SERVICE BULLETIN

B-075

Safety Recall Code 0834

2008 1125R TRANSMISSION JET RECALL

Figure 2. Oil jet kit

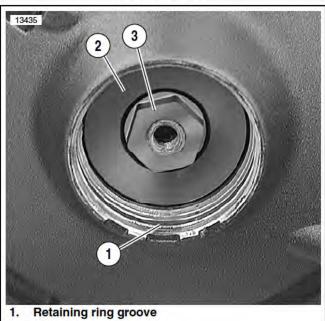
See Figure 2. The retaining ring (2) holds the actuator piston in place to prevent spilling of clutch fluid.

Figure 10. Oil Jet

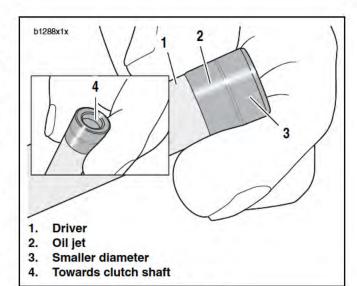
See Figure 10. Apply 2-3 drops of LOCTITE 648 (green) or equivalent onto the smaller outside diameter (3) of the oil jet.

See Figure 10. To install oil jet (2), use a driver (1) that has a larger diameter than the oil jet. The smaller diameter (3) of oil jet faces clutch shaft.

Figure 12. Installed Oil Jet

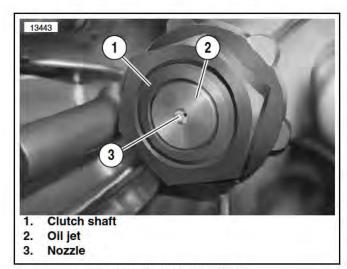
See Figure 12. If oil jet has already been installed as a result of efforts by Buell Racing Support, proceed to step 18.

- See Figure 12. Install oil jet (2) into clutch shaft (1) until oil jet is flush with end of clutch shaft.
- Clean oil jet with compressed air and make sure nozzle
 is not blocked.
- 18. See Figure 13. Fit the stepped washers and fasteners to the springs and install the pressure plate and springs.
- Install the springs in a cross pattern until the fasteners bottom
- 20. Tighten the fasteners to 89 in-lbs (10 Nm).
- See Figure 14. Verify that the two needle pins (1) are in place in the clutch cover.
- 22. Install the diaphragm cover gasket (2).
- See Figure 7. Apply LUBRIPLATE No. 105 Motor Assembly Grease to the bore of the inner clutch diaphragm cover (2).
- Fit the diaphragm cover with the embossed BUELL side out.
- 25. Install inner disc plate (1) with side stamped "OUT" facing away from engine.
